# APPLICATION FOR A RESIDENTIAL SITE IMPROVEMENT PERMIT/ CONSTRUCTION AUTHORIZATION FOR AN ON-SITE WASTEWATER SYSTEM, NEW WELL INSTALLATION, OR REPAIR OF EXISTING WELL

# SOIL/SITE EVALUATION for ON-SITE WASTEWATER SYSTEM

**IMPROVEMENT PERMIT DENIAL**

Re: Application for Improvement Permit for property located at 7016 BRANDON PLACE RD , MECKLENBURG, NC 28227
Parcel No.: 13913456
Health Department File No.: SP26-064

# Soil & Site Evaluation Map

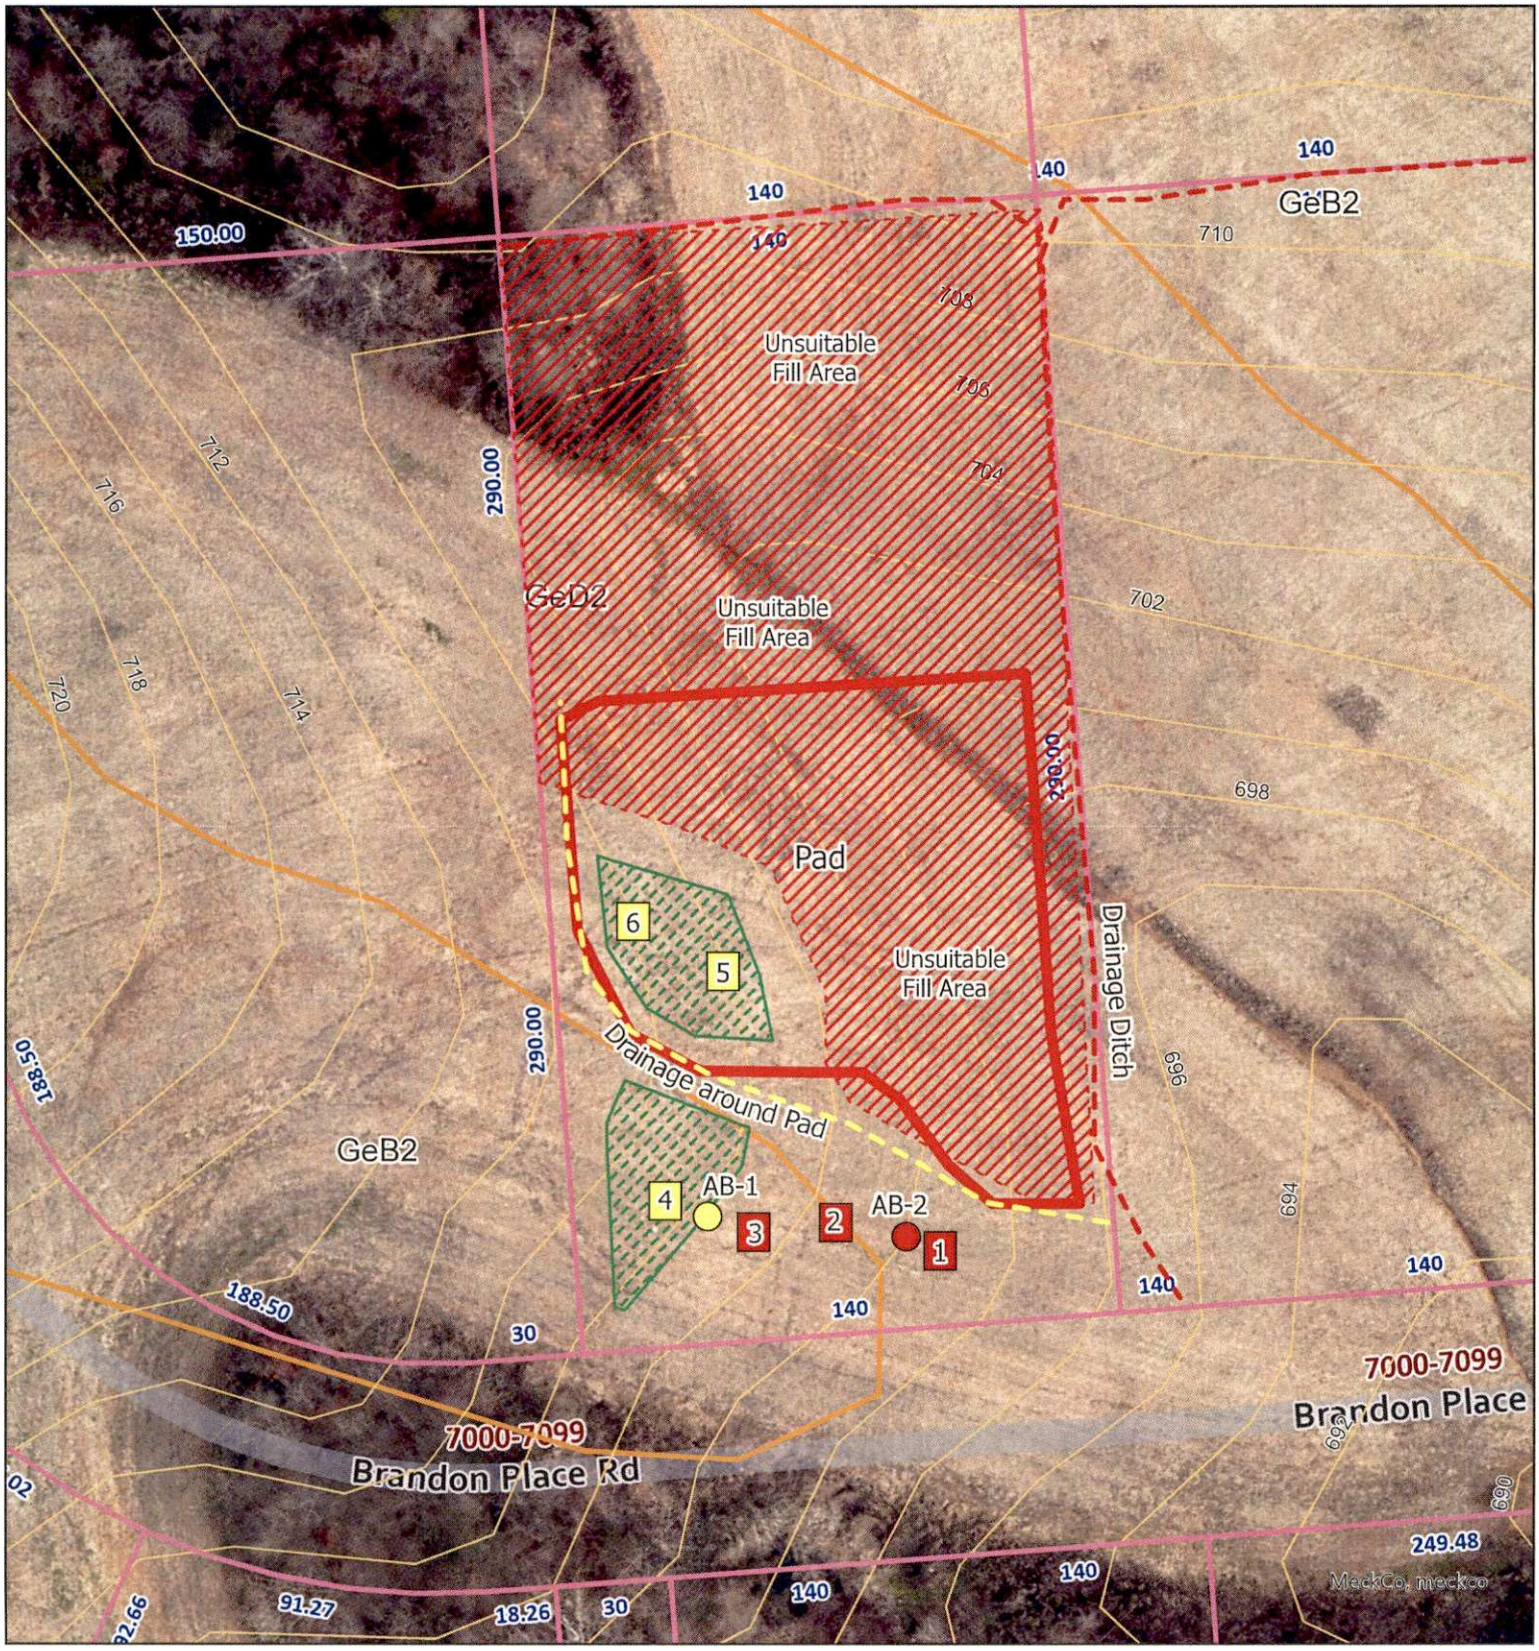
**COMMENTS:** Due to unsuitable soil depths, unsuitable saprolite, unsuitable fill materials, positive drainage around slab pad, and large unsuitable fill area there likely is insufficient space available to support a 4 BR SFR system and repair area.

Based on the criteria set out in 15A NCAC 18E .0501 through .0602, the evaluation indicated that the site is **UNSUITABLE** for an on-site wastewater system. Therefore, we must deny your request for an Improvement Permit. A copy of the site evaluation is enclosed. The site is unsuitable based on the following:

- ☐ Unsuitable soil topography and/or landscape position (Rule .0502)
- ☒ Unsuitable soil characteristics (structure or clay mineralogy) (Rule .0503)
- ☐ Unsuitable soil wetness condition (Rule .0504)
- ☒ Unsuitable soil depth (Rule .0505)
- ☒ Unsuitable saprolite (Rule .0506)
- ☐ Presence of restrictive horizon (Rule .0507)
- ☐ Insufficient space for septic system and repair area (Rule .0508)
- ☐ Unsuitable for meeting required setbacks (Rule .0601 or .0602)
- ☐ Other (Cite applicable rule):_____

The site evaluation included consideration of possible site modifications, as well as use of all possible systems approved under 15A NCAC 18E. However, the Health Department has determined that none of the above options will overcome the severe conditions on this site. A possible option might be a system designed to dispose of sewage to another area of suitable soil such as off-site to additional property.

A site classified as UNSUITABLE may be classified as SUITABLE if written documentation is provided that meets the requirements of Rule .0509(b) or (c). A copy of this rule is enclosed. You may hire a consultant to assist you if you wish to try to develop a plan under which your site could be reclassified as SUITABLE.
